Fire Sprinkler Rehabilitation

Gulf of Georgia Cannery, Steveston, B.C.

**FIRE SPRINKLER REHABILITATION
GULF OF GEORGIA CANNERY, STEVESTON, B.C.
PROJECT NO. R.089515.001
MECHANICAL ADDENDUM NO. M1**

REFER TO MECHANICAL TENDER DRAWINGS AND SPECIFICATIONS AND ATTACHED REVISED DRAWINGS F-1, F-2, F-4 AND F-5:

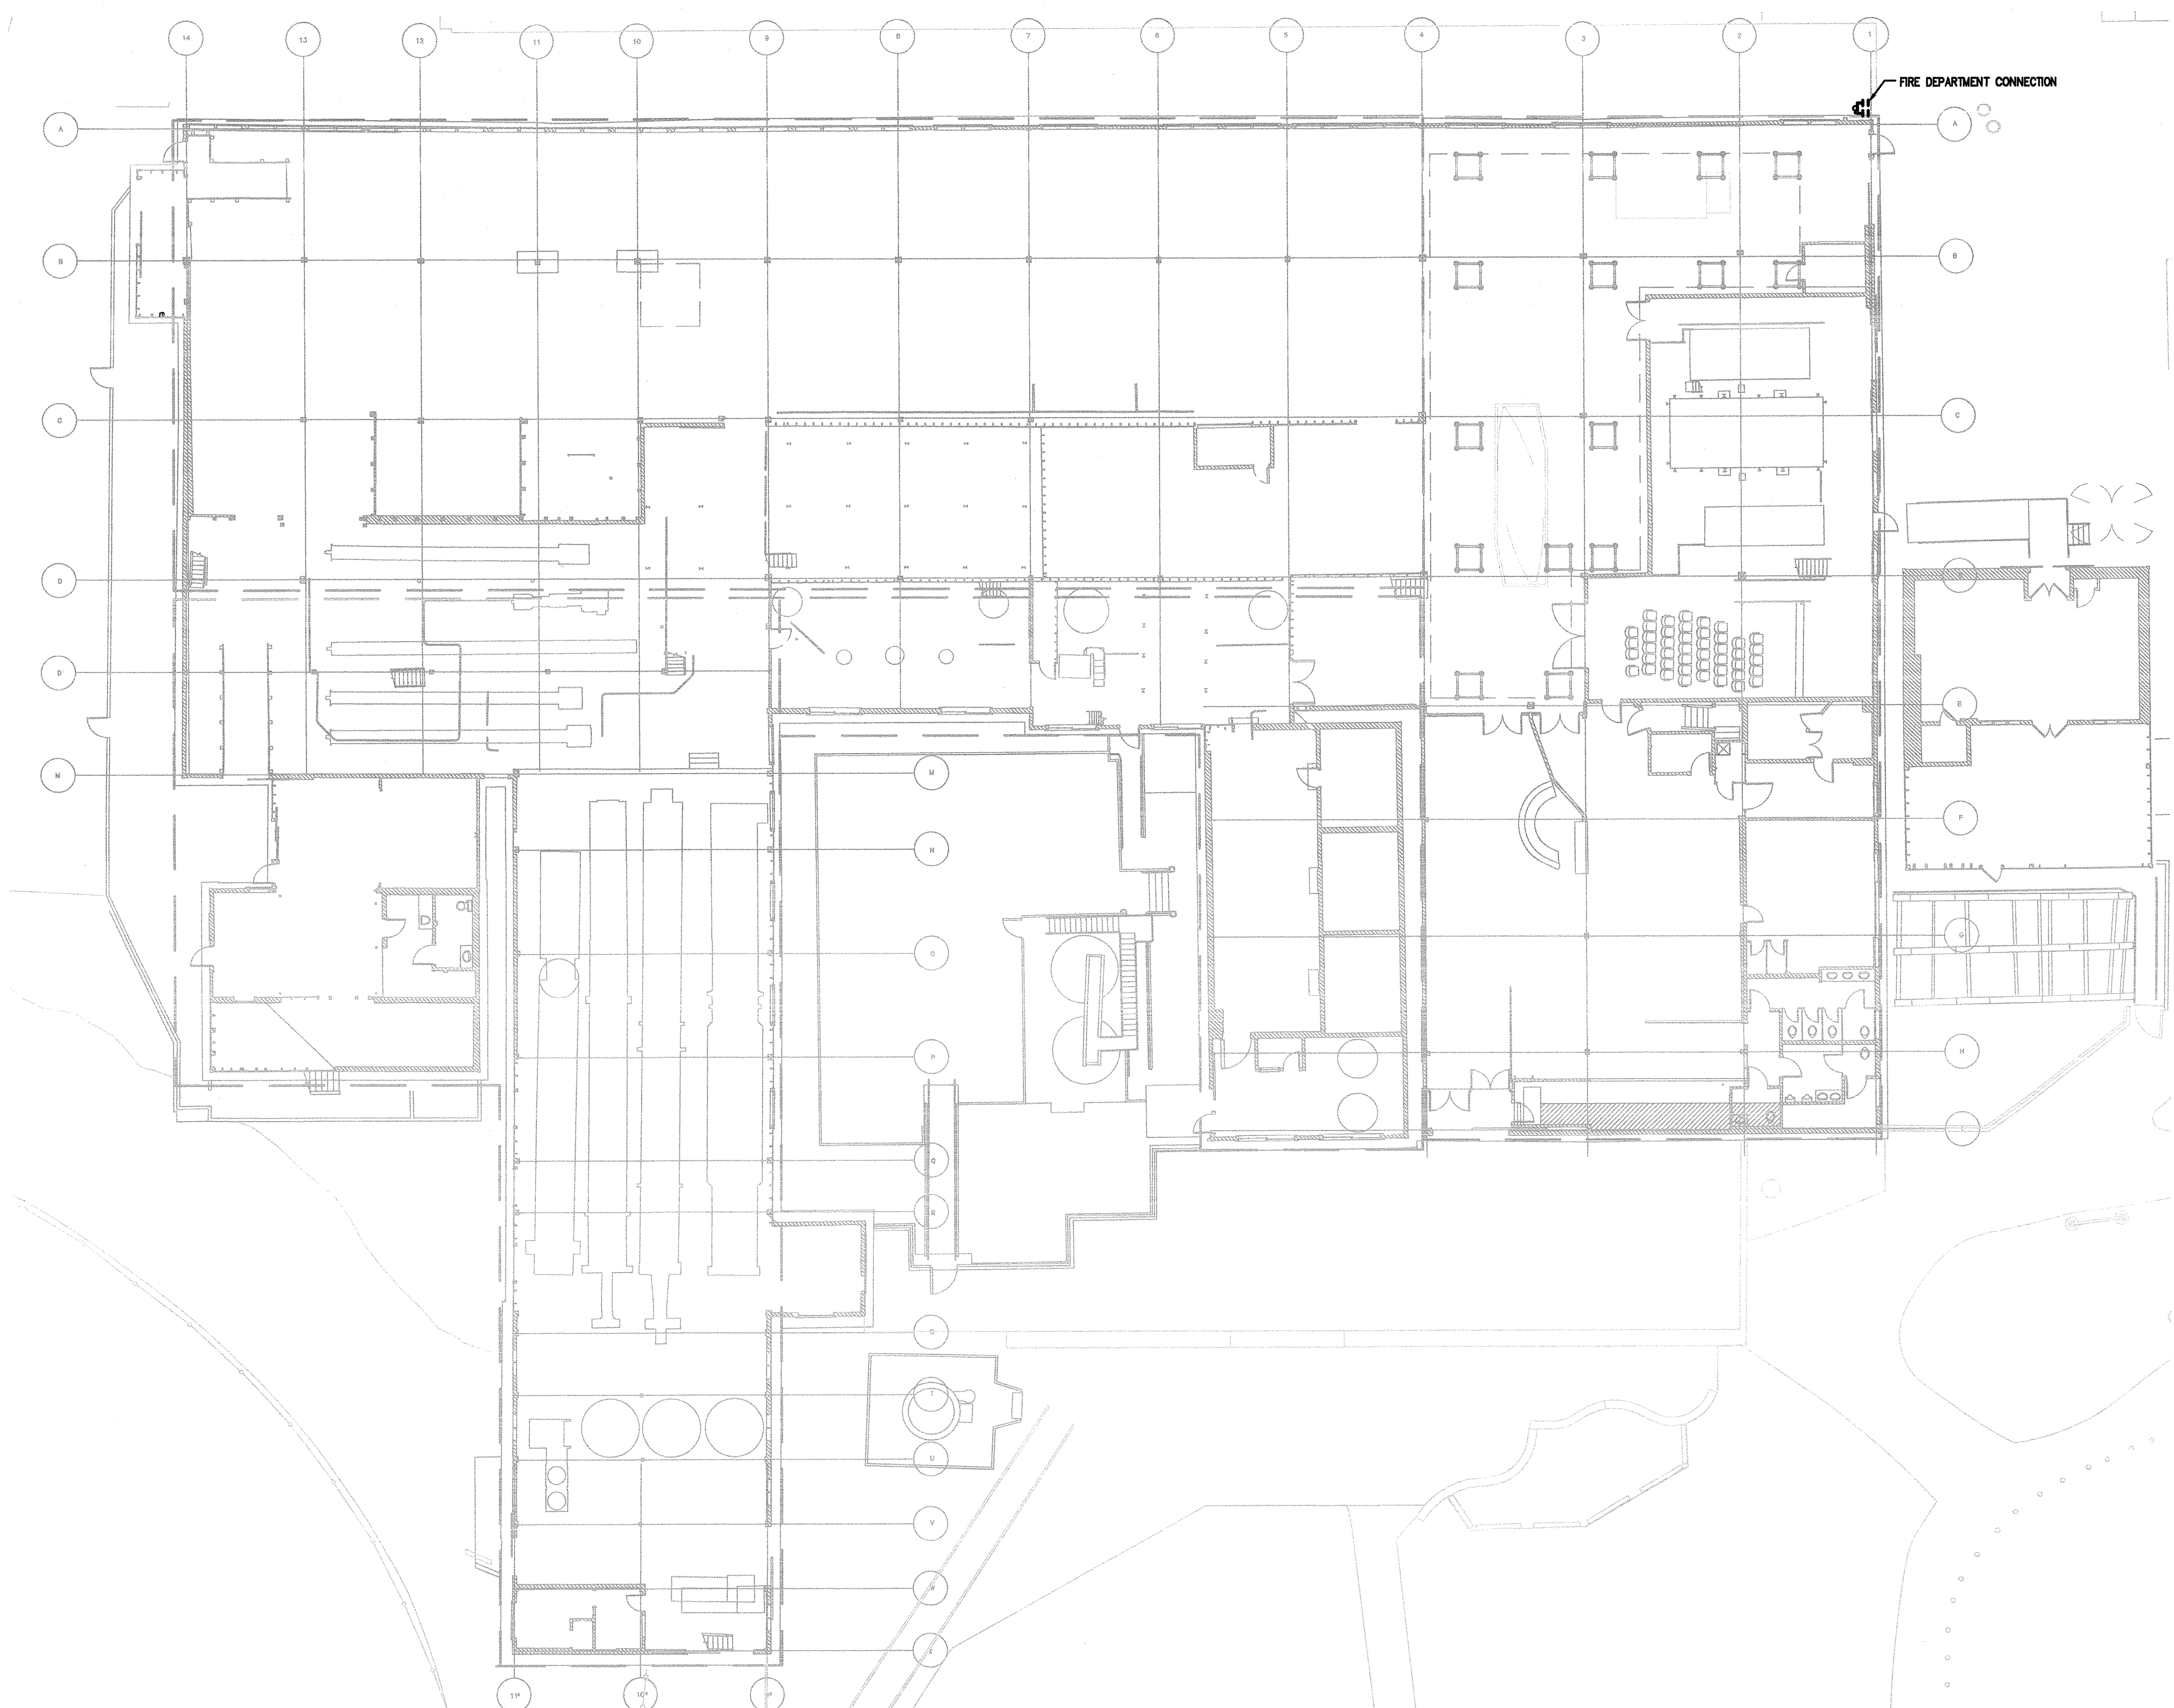
1. Delete stainless steel pipe, valves, fittings and pipe hangers for the substructure sprinkler systems.

2. Delete dry pipe valve station for substructure sprinkler Zone 1 located in the Mezzanine Remote Sprinkler Valve Room.

3. Delete system low point drain and piping for sprinkler Zone 1.

4. Delete stainless steel sprinkler drainage system in the substructure.

5. Delete nitrogen Purge Valve (PV-1) for sprinkler Zone 1.
Provide nitrogen Purge Valves PV-1A and PV-1B and piping for sprinkler Zones 1A and 1B. Locate valves in corridor and mount on the North wall near the office and washroom in the Ice House main floor.
6. Delete stainless steel Fire Department Connection and piping.
Provide hot-dipped galvanized Fire Department Connection and piping.
7. Delete stainless steel escutcheon plates.
8. Delete piping protection from high tide for piping in the substructure.

Provide hot-dipped galvanized steel pipe, valves, fittings and pipe hangers for the substructure sprinkler systems.

Provide dry pipe valve stations for substructure sprinkler Zone 1A and Zone 1B in the Mezzanine Remote Sprinkler Valve Room. Refer to revised sprinkler system layout, pipe routing and piping of zones. Install 2@ 200mm pipe risers to substructure sprinkler Zone 1A and Zone 1B in Temporary Exhibit along the North wall, grid line C and 10.

Provide system low point drain and piping for sprinkler Zone 1A and Zone 1B. Connect 2@ 50mm drains to sprinkler drainage system in the substructure.

Provide hot dipped galvanized steel sprinkler drainage system in the substructure.
